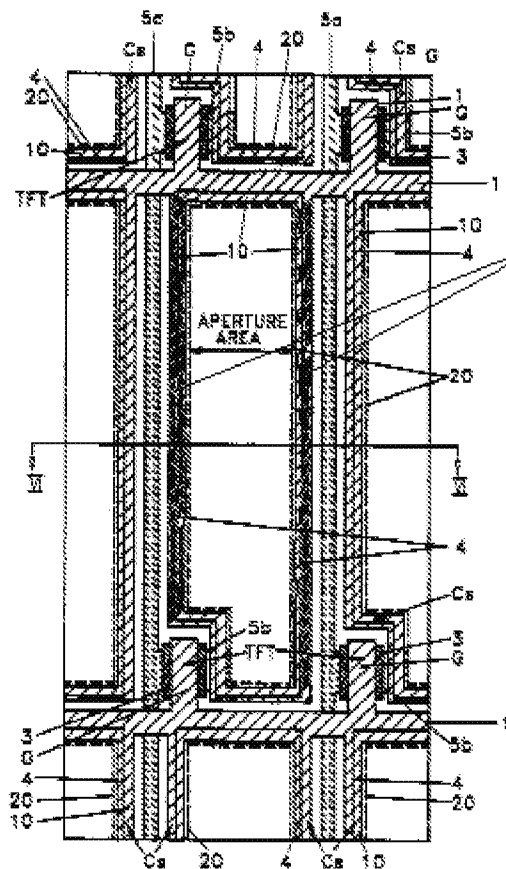
In regard to claim 1, Kim et al. disclose (Figs. 3G-J) a multi-domain liquid crystal display device comprising:

- a plurality of data lines 5a for applying a data signal on the first substrate;
- a plurality of gate lines 1 for applying a gate signal, the gate lines crossing the data lines to define a plurality of pixel regions,
- a thin film transistor near each crossing of the gate lines and the data lines;
- a common electrode 17 on the second substrate;
- a pixel electrode 13 connected to a drain electrode of the thin film transistor in each pixel region; and
- an auxiliary electrode line 10 electrically connected to at least one of the common lines in each pixel region,

the auxiliary electrode line connects to gate line and takes advantage of the gate signal applied to the gate lines would cause the disturbance of liquid crystal molecules because the auxiliary electrode may distort an electric field applied between the common electrode and the pixel electrode to generate a fine domain at right above the auxiliary electrode

- the auxiliary electrode line is formed between the pixel electrode and the data line at an outside of the pixel electrode in the pixel region and the auxiliary electrode is not overlapped with the data line.
- the auxiliary electrode line inherently takes advantage of the gate signal applied to the gate lines.
- the gate line has a larger width than the auxiliary electrode line.

Kim et al. fail to disclose (a) each pixel region having a multi-domain structure which includes slit or opening area in the common electrode; thus the auxiliary electrode line and the multi-domain structure distorting an electric field applied between the common electrode and the pixel electrode to thereby form at least two domains in each pixel region during an operation of the multi-domain liquid crystal display and the auxiliary electrode line takes advantage of the gate signal applied to the gate lines inherently to form the multi-domain; (b) the auxiliary electrode line comprises a first region which does not overlap with the pixel electrode and a second region overlapping with the pixel electrode, herein the first region is larger than the second region.
